APPENDIX B:

SUBMISSIONS

**Springvale Water Treatment Project (SSD 7592)
Review of Environmental Impact Statement**

Attachment 1: WaterNSW's comments on the EIS for the Springvale Water Treatment Project (SSD 7592)

FIGURE 10

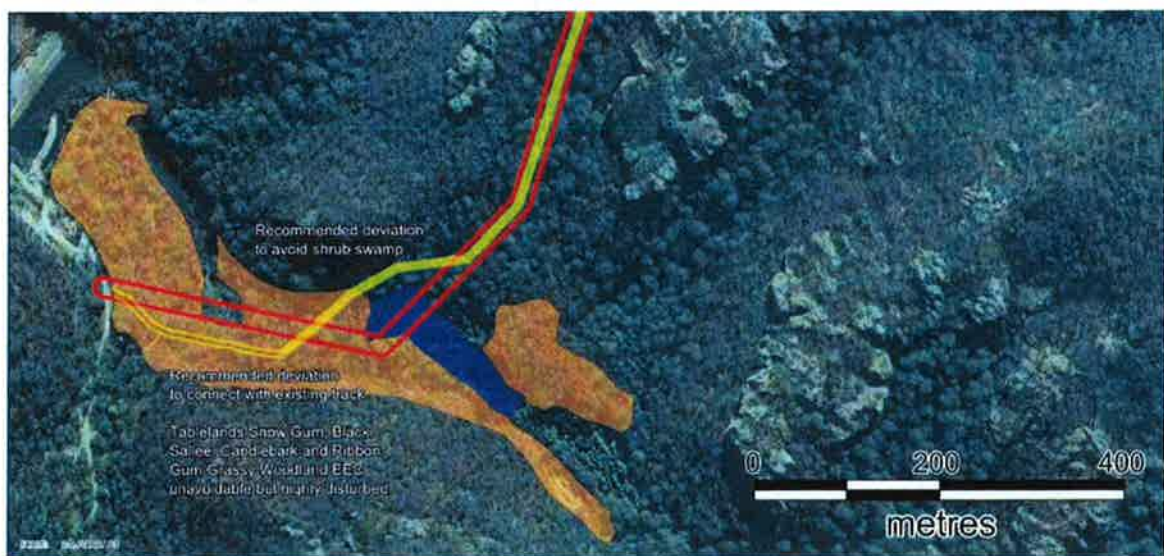
Proposed pipeline and road route descends through a gully that lies between Clerestory Spurs 7 and 8 and then proposes to clear MU11, an endangered ecological community. How can this be less damaging than following the existing pipeline easement, and what are the justifications for pipeline relocation? (figure below from the 2014 Springvale Mine extension EIS).

2 Duplicates escarpment disturbance

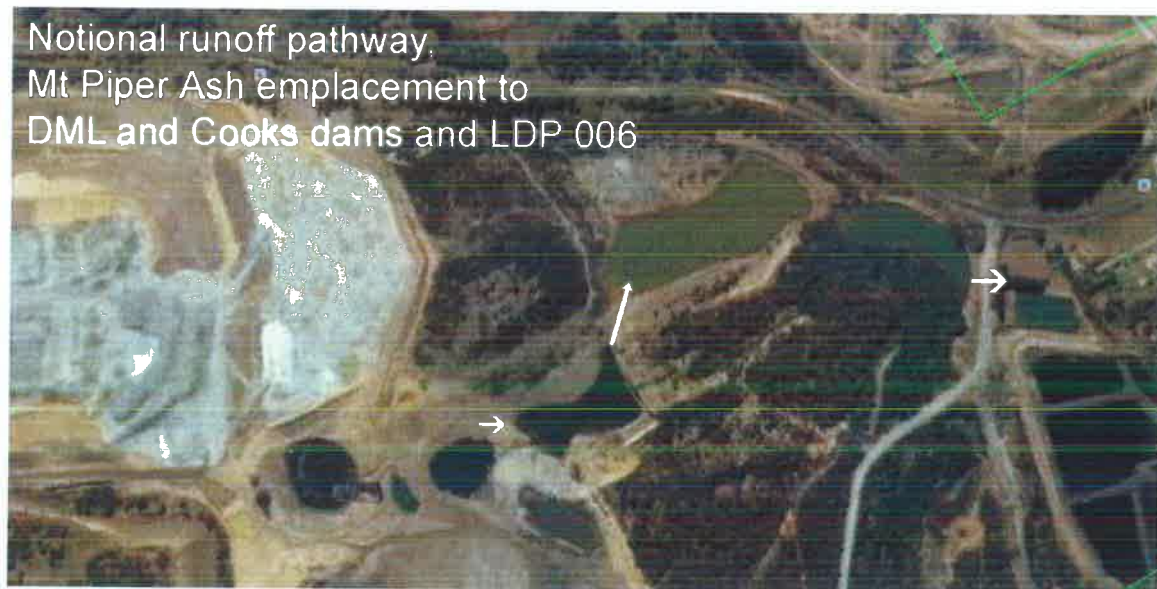
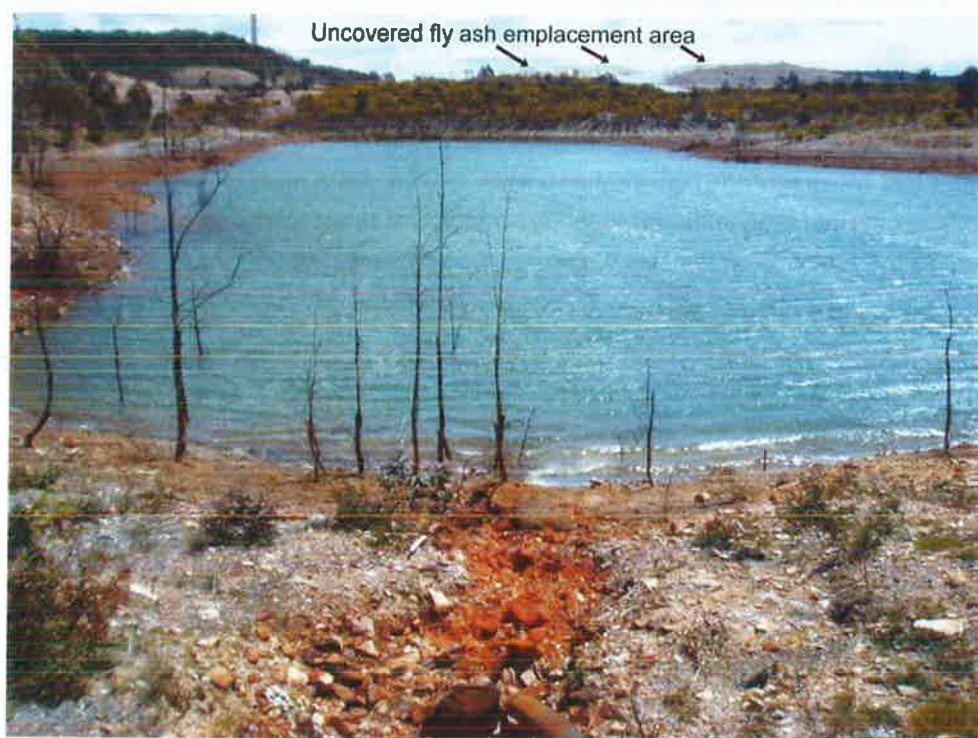
From examination of images of Cooks Dam, the adjoining DML Dam and the Ash Emplacement, as well as Google Earth images, the Cooks Dam seems to be hydrologically connected with the Ash Emplacement Area through the DML Dam and various storages to the west that spill into it.

The uncovered fly ash emplacement area has not been continuously rehabilitated as revealed in this 2016 Google Earth image, above, and a plume highly saline groundwater and runoff finds its way to LDP 006 and Wangcol Creek via DML Dam below. Note also the scour due to discharge from pipe shown at bottom of image.

The proposed increased discharges from LDP 006 are unacceptable. The highly saline discharges from LDP006 must be removed from the Coxs River catchment by reuse after water treatment in the power plant.

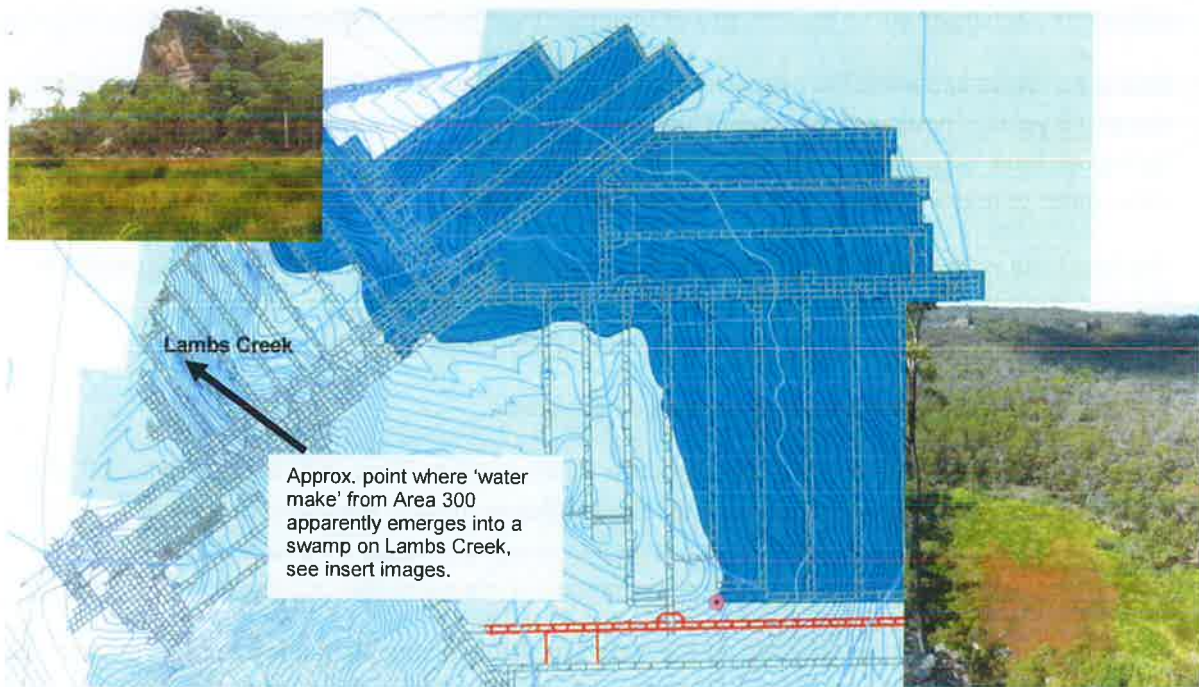
Angus Place Mine has in the past denied that it is possible for mine water to emerge at Lambs Creek as their storage is about 100 metres below the surface. The Colong Foundation retains doubts about this underground storage and Lambs Creek. The large unnatural 'spring' on Lambs Creek at the point indicated below remains a mystery.

The figure and inset images above indicate the arrangement of Angus Place underground storage and a very

green, iron stained swamp that lies above it. Swamps that receive mine effluent, such as those at the Baal Bone Colliery have a similar appearance.

The Colong Foundation opposes use of this underground storage as part of the Springvale Water Treatment project. The spring that surfaces at Lambs Creek is suspect and probably contaminated
